Ventura Westside Community Planning Project

Final Environmental Impact Report

FIGURE 4.14.2-1

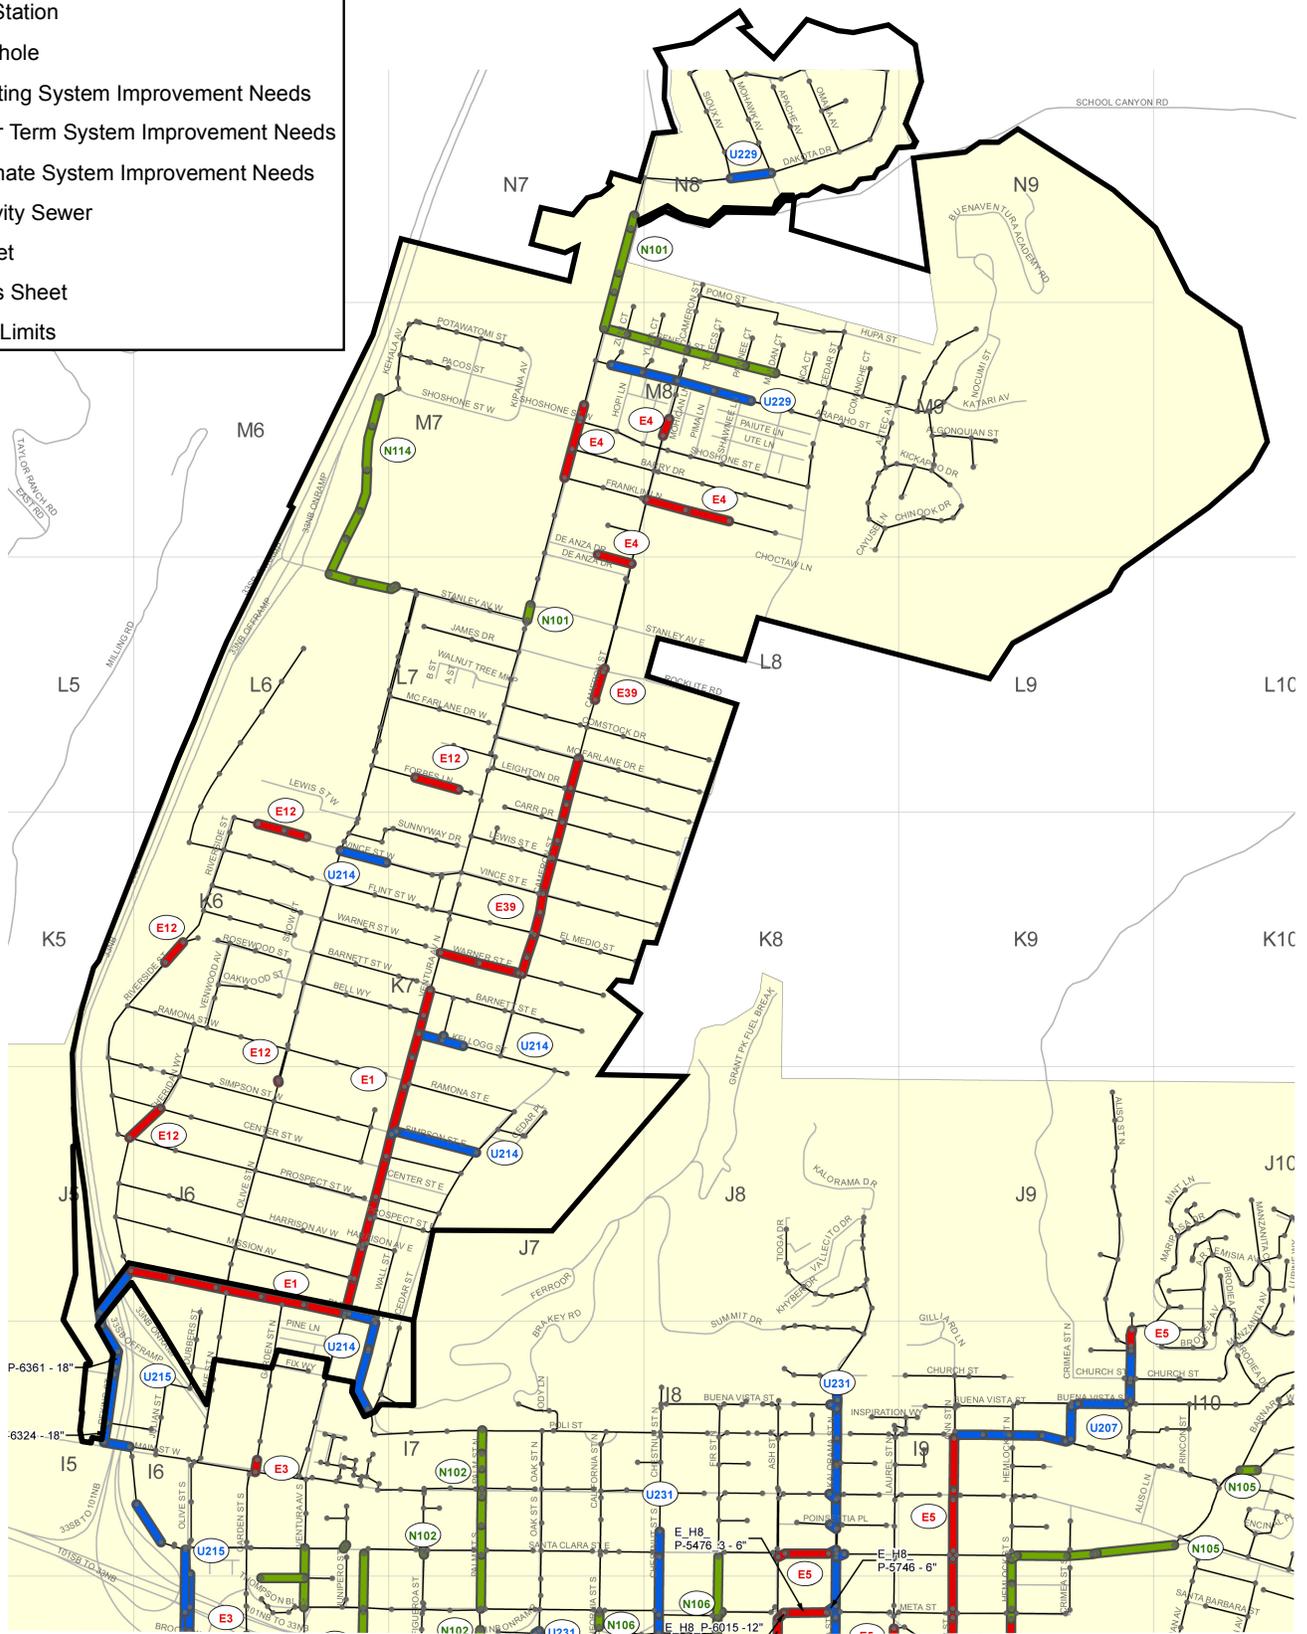
101. page 4.14.2-5 Figure 4.14.2-1 has no legend or key to explain the different color markings.

Figure 4.14.2-1 has been revised in the Final EIR to provide a legend to interpret the illustrated wastewater system improvements.
